Comment	Response
Environmental Protection Department (contact: Jolene Wong, Tel: 2835 1844)	
<u>From AQ perspective</u>	
<p>1. Section 8.6: According to the management plan, there will be 接待 / 登記 / 等候室, meeting room and ceremony room in one of the ancillary blocks. Please refer to our previous comments stating that office areas within the proposed development would be considered air-sensitive uses. In addition, visitors to the proposed development are also considered short-term ASRs. The Applicant needs to address the potential air quality impact from nearby emission sources on any air-sensitive uses within the proposed development.</p>	<p>The proposed Columbarium, located in a rural area with dense vegetation, is free from industrial chimneys within 200 meter radius. Burning is prohibited at the Columbarium itself. Initial information suggests infrequent, small-scale burning near nearby temples and monasteries. While incense, joss paper, and candles are expected to be burn more frequently during the Ching Ming and Chung Yeung festivals, the Columbarium will be closed for one week before and one week after each festival. Consequently the Columbarium is not anticipated to have a sig

DRAWING NO.	FIGURE T1	REV.	.
-------------	-----------	------	---

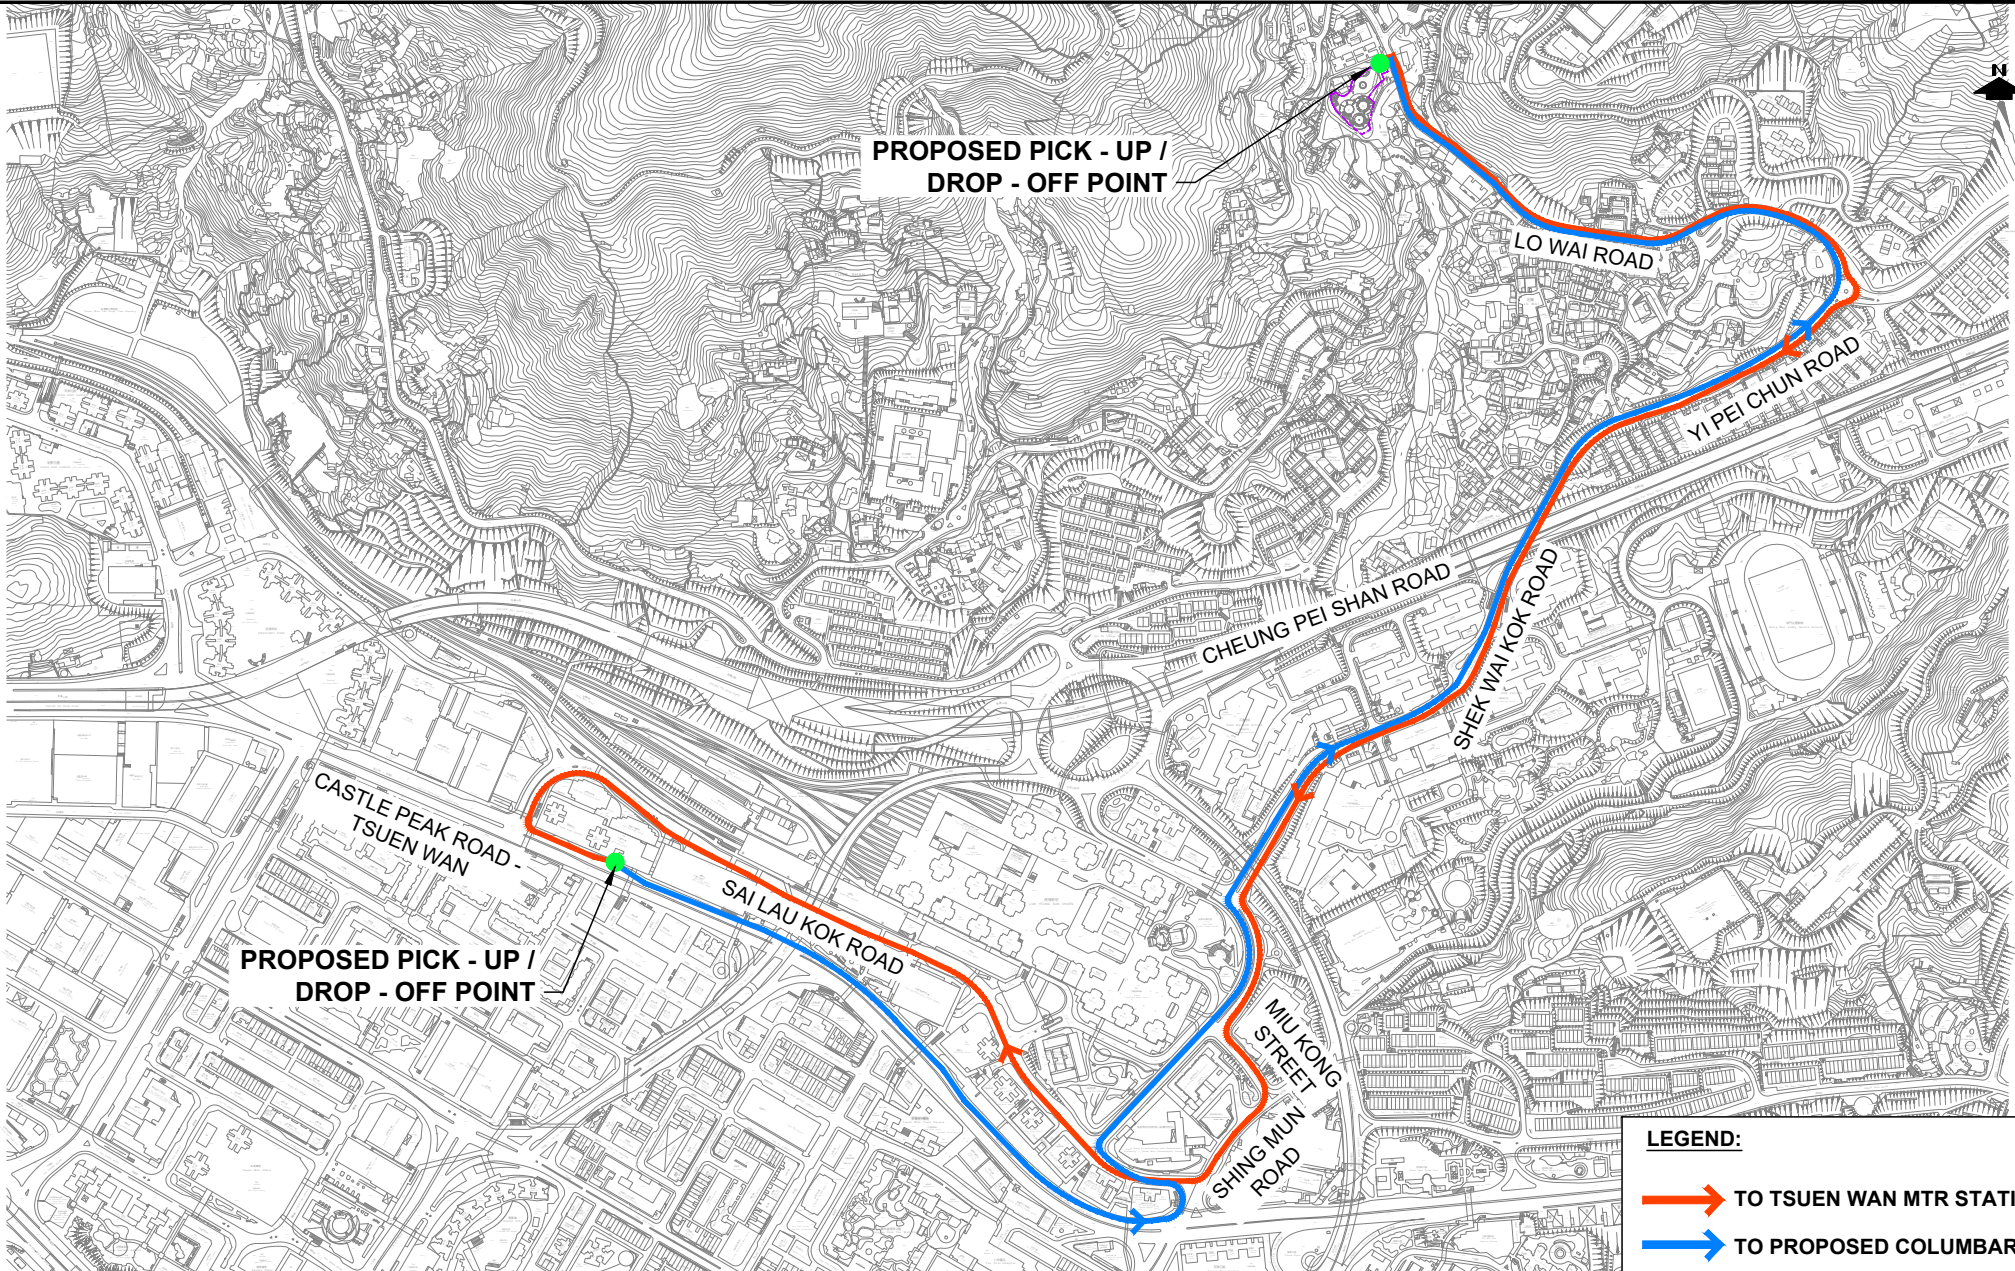
1. The TIA should include a detailed assessment of the demand for and provision of public transport services related to the development. The assessment should also examine whether any enhancements to transport facilities, including modifications to bus bays and/or lay-bys, are required to facilitate access for visitors to the development.	<p>Due to the resource limitation of public transport operator, the number of minibuses cannot be further increased and the number of vehicle trips per hour would remain the same as the existing.</p> <p>To cater for the additional passenger demand generated by the proposed columbarium, the Applicant will provide a shuttle service the Site and the Tsuen Wan MTR Station. A preliminary routing and pick-up/drop-off point is shown in the attached Figure T1 while the detailed routing and the pick-up/drop-off point will be submitted under the Management Plan during license application. No demand on the public transport services will be induced by the proposed development.</p>
